How to update T32MZ

T32MZ SOFTWARE UPDATE CHANGES**(Editor Version: 3.6.1 Encoder version: 1.3)**

◆ S.BUS Basic screen

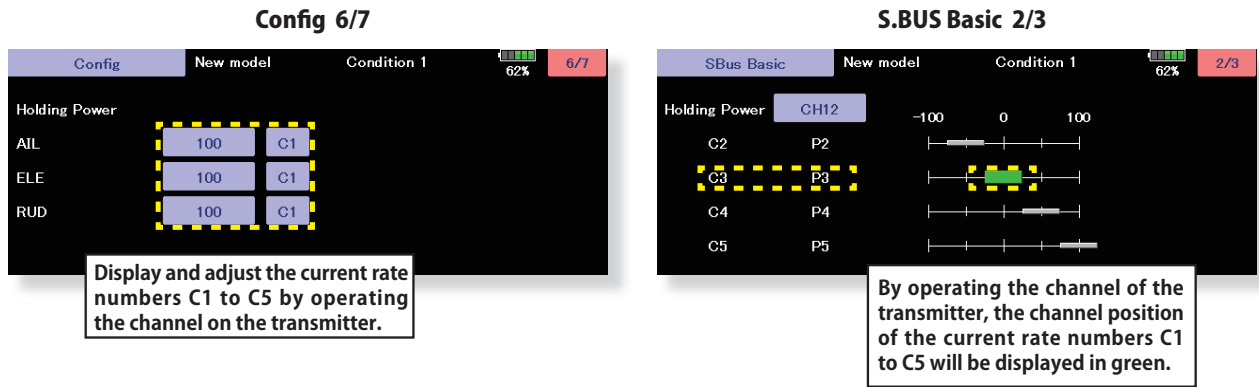
Added the setting of switching CH of holding power rate C1 to C5 to S.BUS basic menu.

The second page has been added, and the total number of pages has changed from 2 to 3.

When set to SW of DG1 or DG2

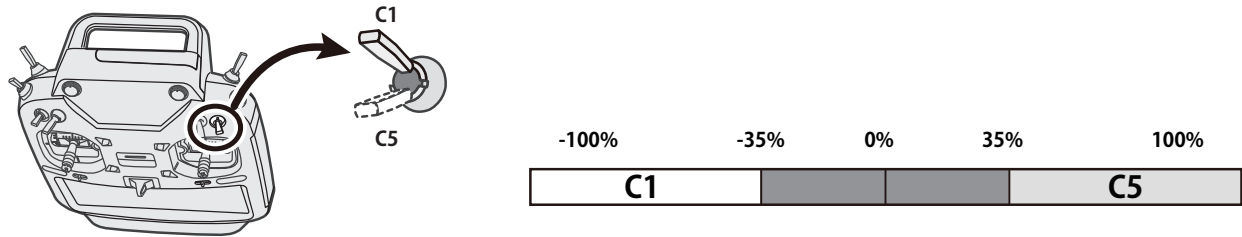
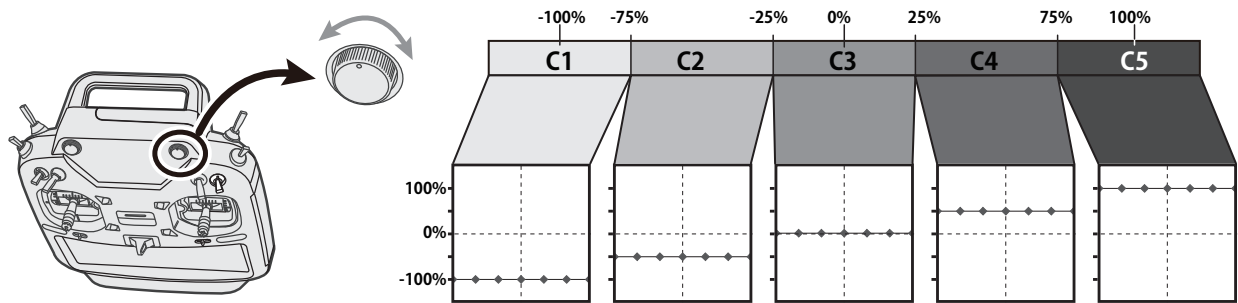
Like the flight condition function of the transmitter, you can set up to 5 different data for the attitude holding force rate of the aircraft in AVCS mode by operating the switch from the transmitter, and switch between them. You can set the holding power rate selector switch to the channel with the AFR function of the transmitter, and set the point for each rate on the AFR point curve to switch. It is also possible to use the flight condition function to work with the flight condition switch.

◆ ESC telemetry display screen

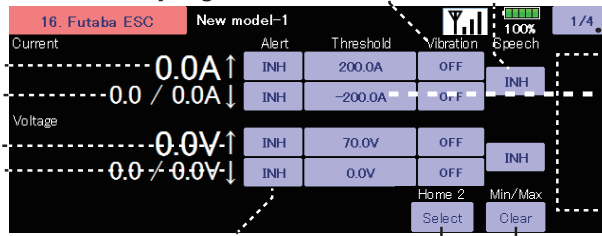
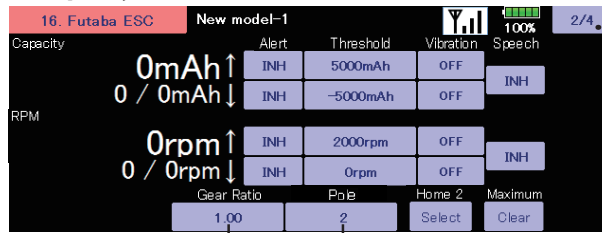
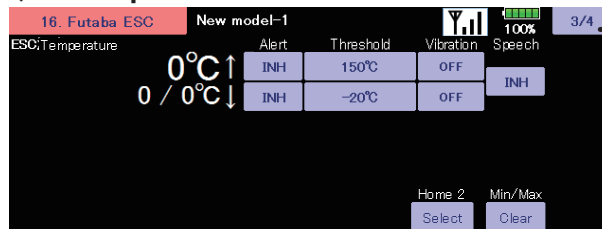
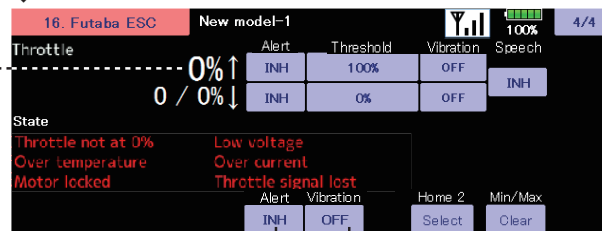
The ESC status is displayed. Alarm setting is also possible.

- Display of each current numerical value
- This display is the maximum and minimum after starting reception until the transmitter is turned off.
- A up arrow shows that the alarm operates, when the set value is exceeded.
- A downward arrow shows that the alarm operates, when less than the set-up numerical value.

2. Add R.P.M. display : Gov Basic

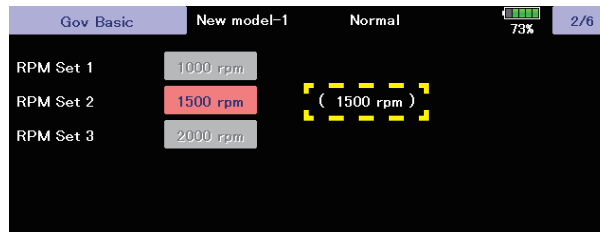
The number of revolutions of the governor setting is displayed on the governor basic screen of the gyro setting.

3. GYA553 Addition of setting parameters

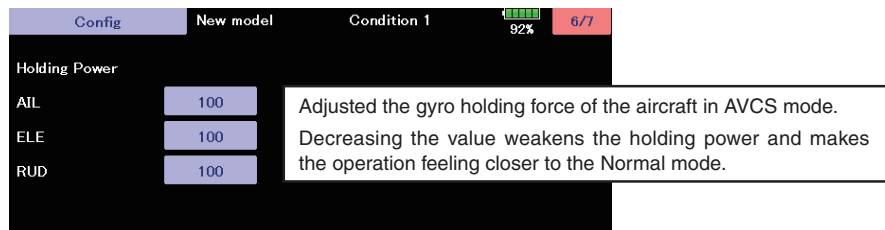
AIL / ELE / RUD holding power setting has been added to the setting parameters of GYA553.

4. Expansion of governor R.P.M. range

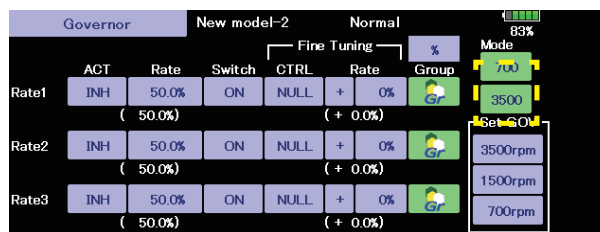
With the governor function of the model menu, the R.P.M. range has been expanded to 700 to 3500 rpm.
